Design Advisory Board

Tuesday, August 27, 2024, 3:00 PM

MEMORANDUM

To: Design Advisory Board
From: Scott Gustin
Re: 251-253 South Union Street
Date: August 27, 2024

PROPOSED
GRADING AND
DRAINAGE PLAN

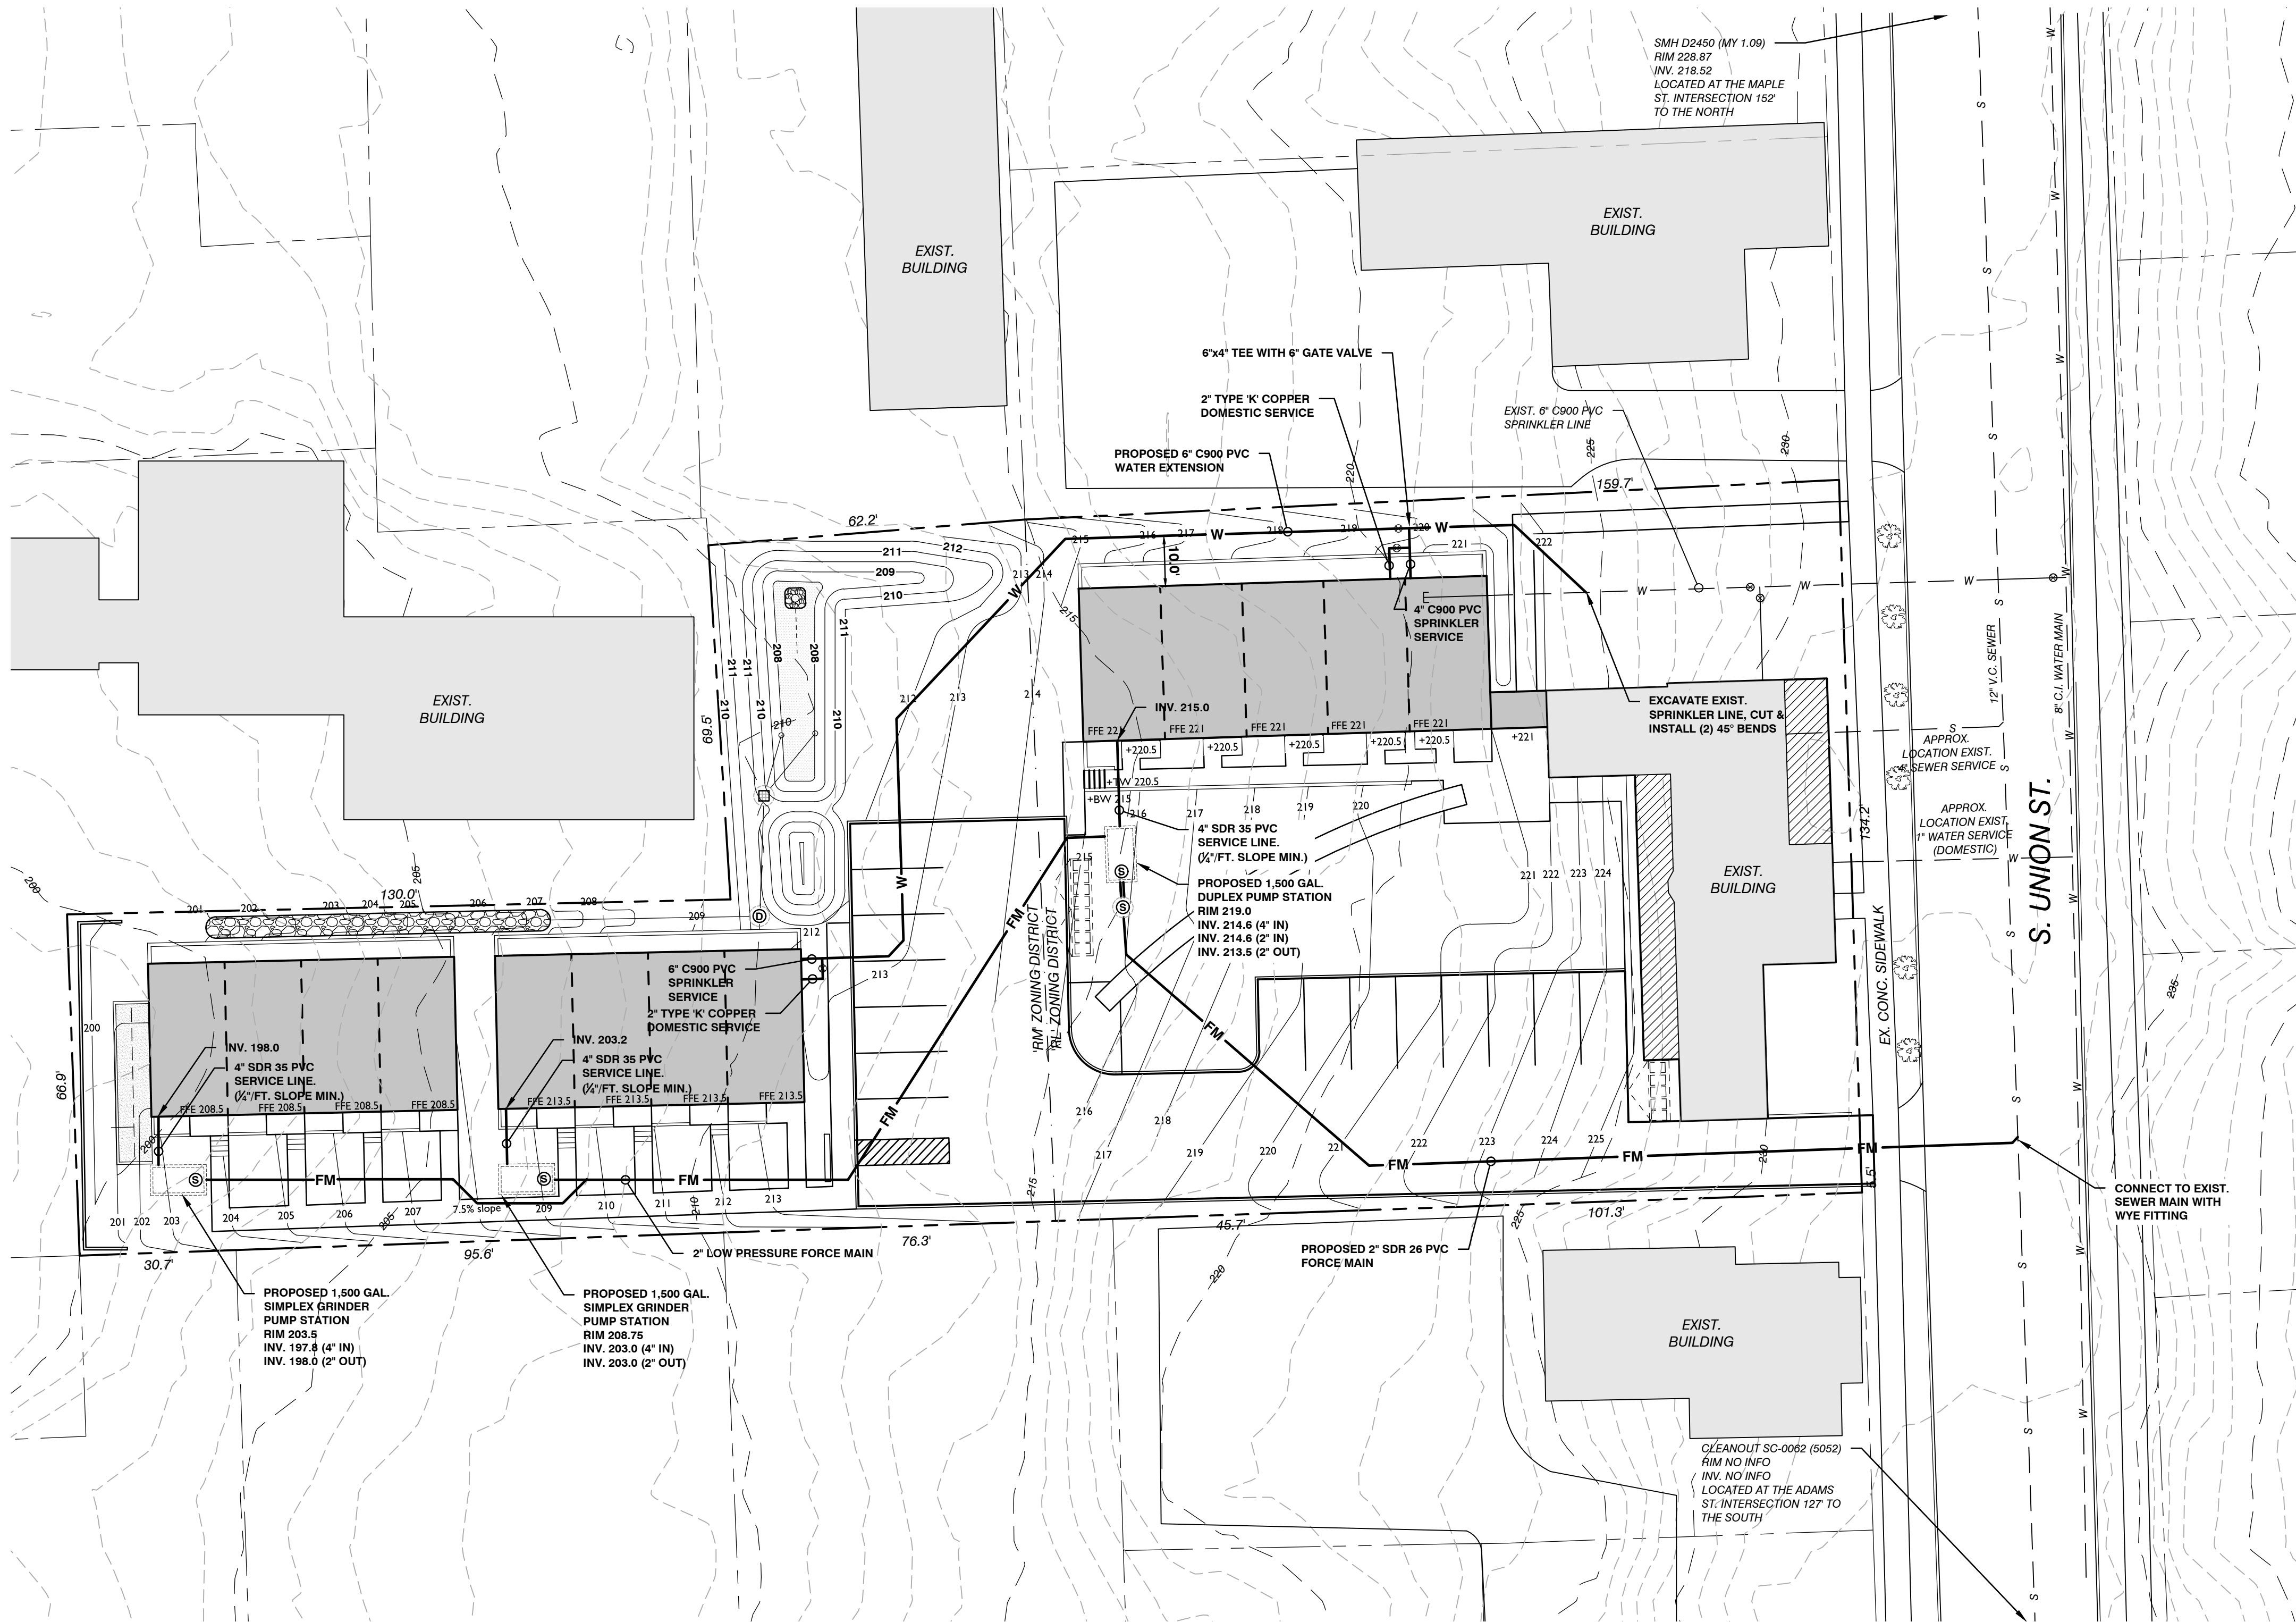
Parking will be substantially reconfigured and expanded to serve the 13 new residential units. Surface material is not noted and must be. Perimeter curbing looks to be proposed. Parking spaces and circulation aisles appear to be dimensionally compliant with the standards of Article 8. As required, parking is set behind the primary building along South Union Street and is split into two smaller areas rather than one large expanse. The proposed 16 parking spaces are enough to require shade trees. This criterion requires at least 1 shade tree for every 5 parking spaces to achieve at least 30% shading of parking and circulation areas. No shade trees or shading analysis are included in the project plans and must be.

Parking spaces encroaching onto the property from the northerly neighbor are not depicted in the project plans and are presumed to be removed. Clarification is needed.

Bike parking is required but is not evident on the project plans. Bike parking must include both long and short term spaces per the standards of Article 8.

- Notation of parking and circulation area surface material.
- Shade trees and related shading analysis demonstrating 30% shading of parking and circulation areas.
- Confirmation of removal (or not) of the northerly parking spaces from the neighboring property.
- Bike parking details (location and type).
- Material and dimensional details for the "light wells."
- Exterior illumination levels (no greater than 5.0 footcandle average for the entries). Parking lot lighting information if any is proposed.
- Infrastructure details such as trash enclosure materials and dimensions, utility meter locations and screening, mail box locations, exterior mechanical equipment locations and screening.
- Perspective drawings and building cross sections.

grading
plan
scale: 1/16"=1'-0"

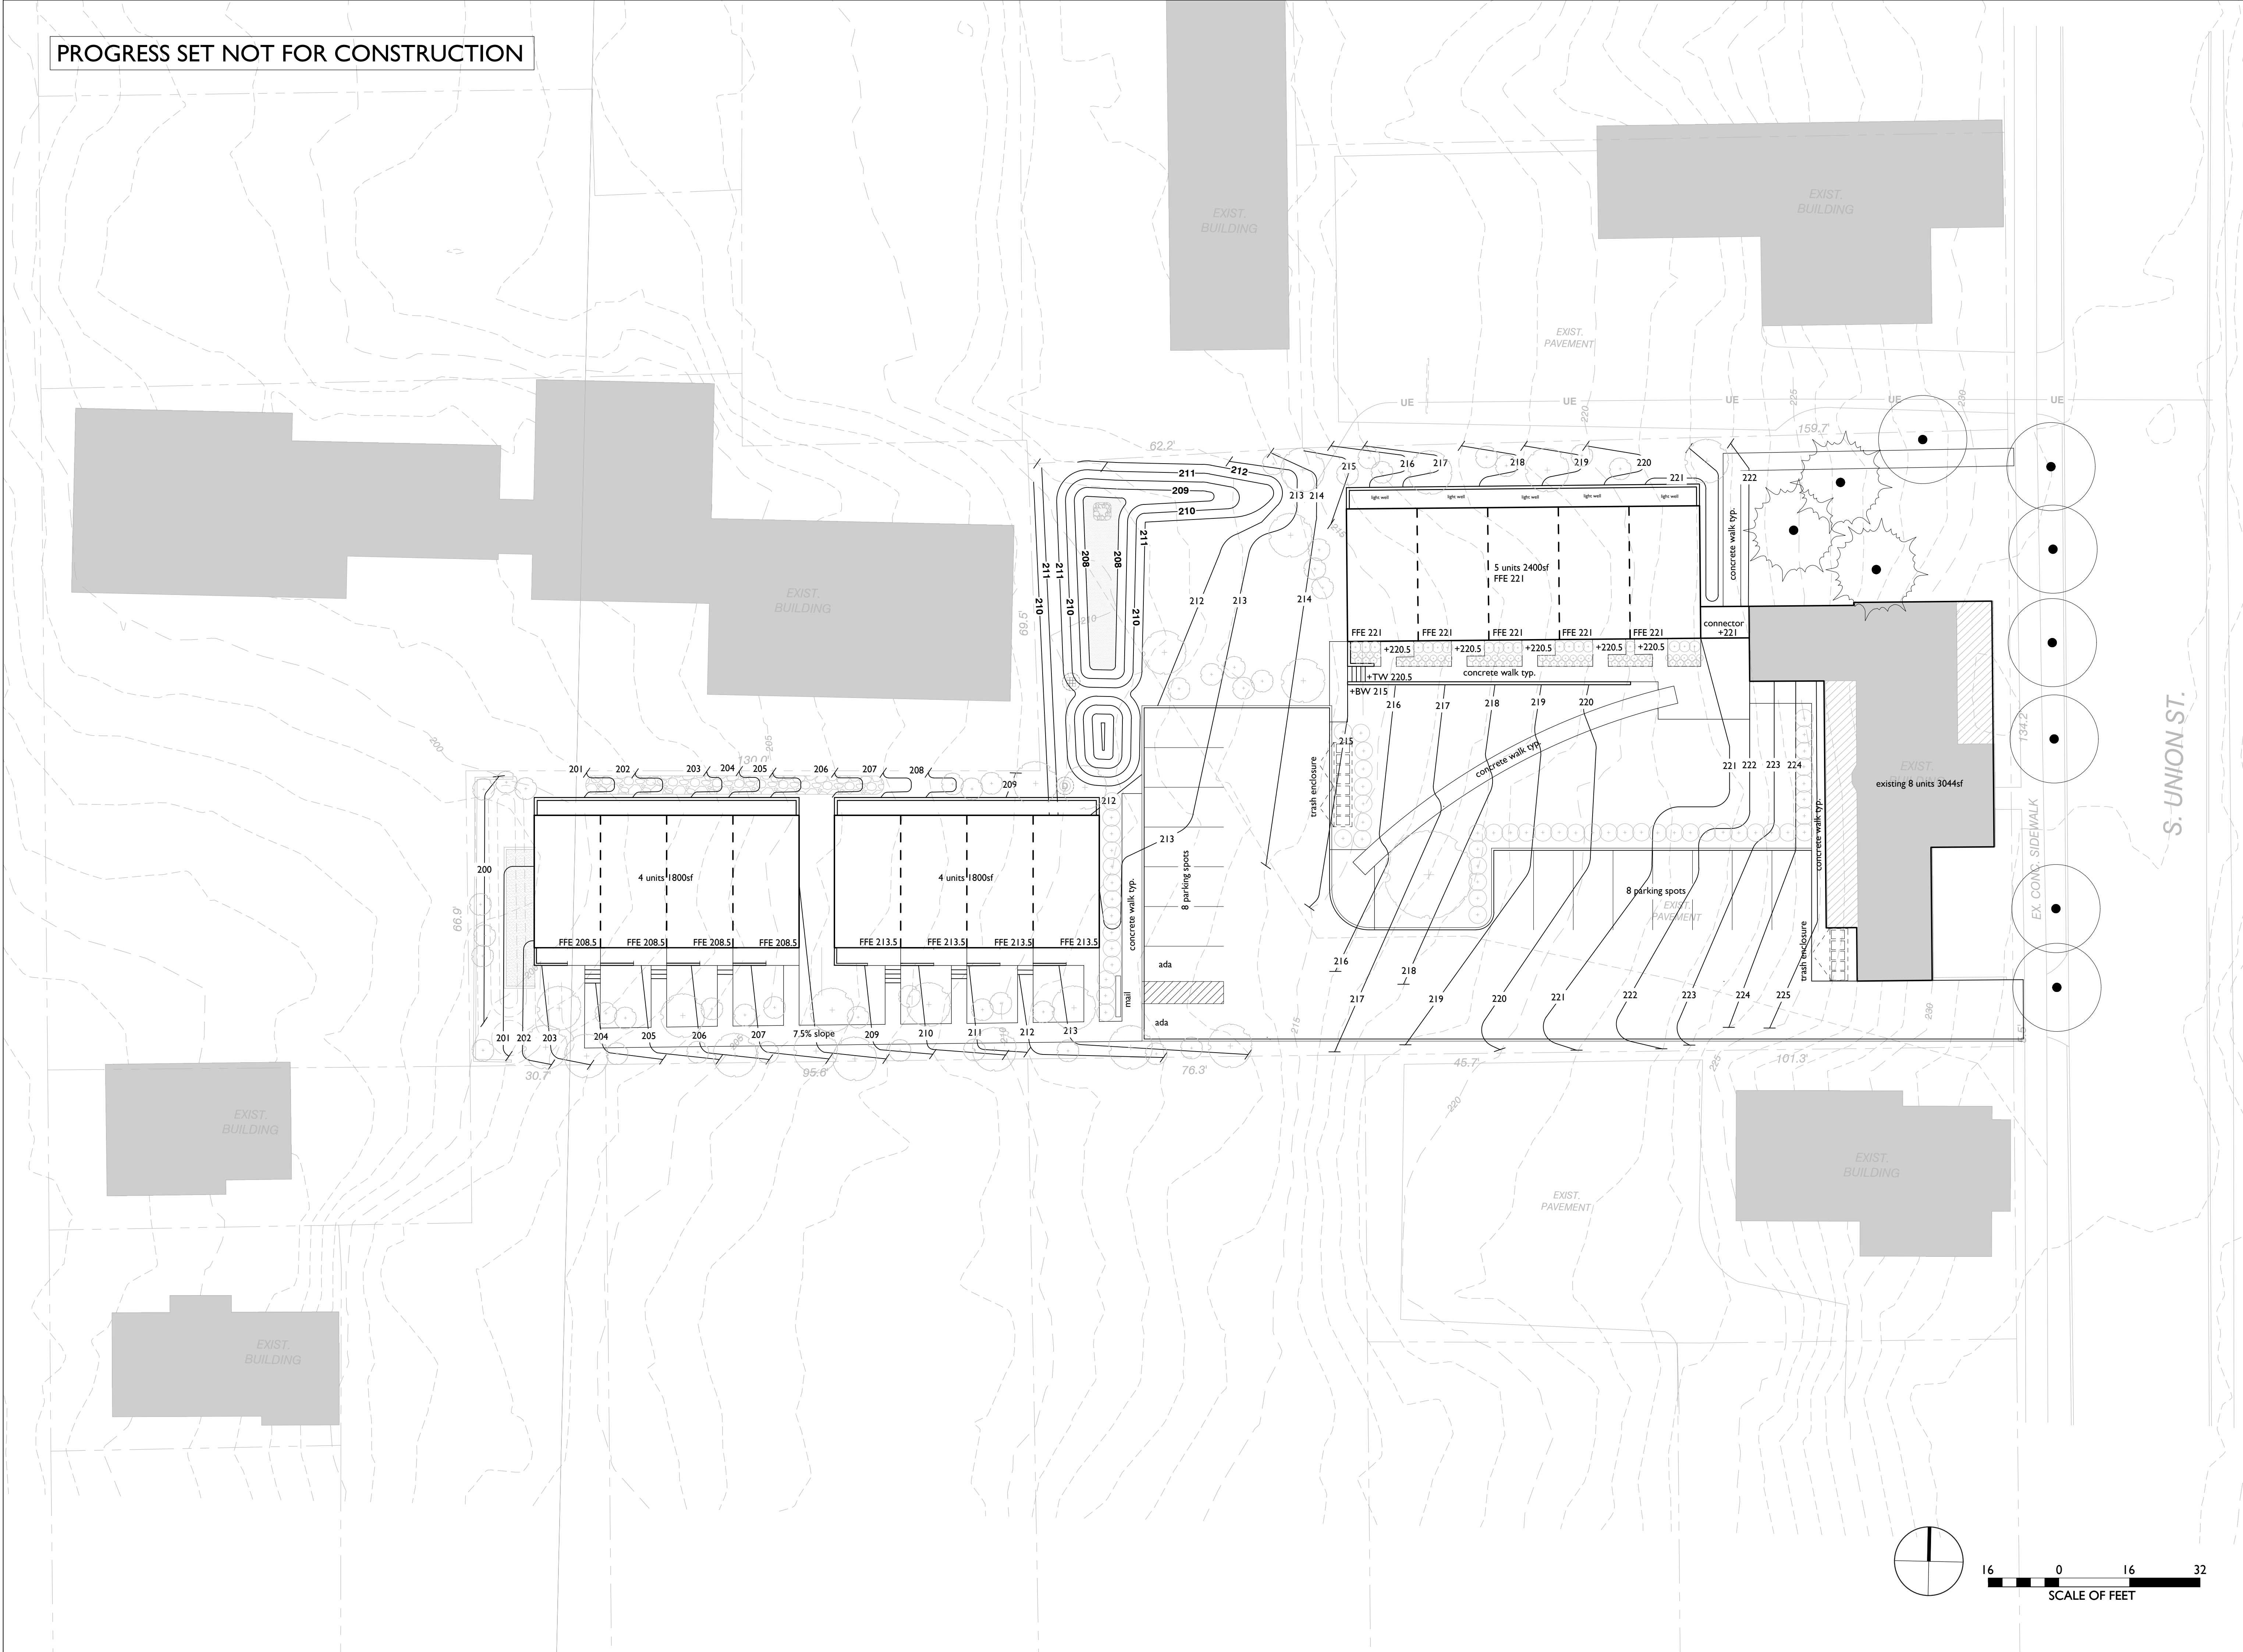
The property has an east-west downslope. The proposed rear addition remains as previously approved. It will be set downslope from, and below, the existing building. The two detached 4-unit buildings are set further downslope at the western end of the property. Project plans depict existing and proposed topo lines. While grading is required, the general sloped characteristic of the property will remain.
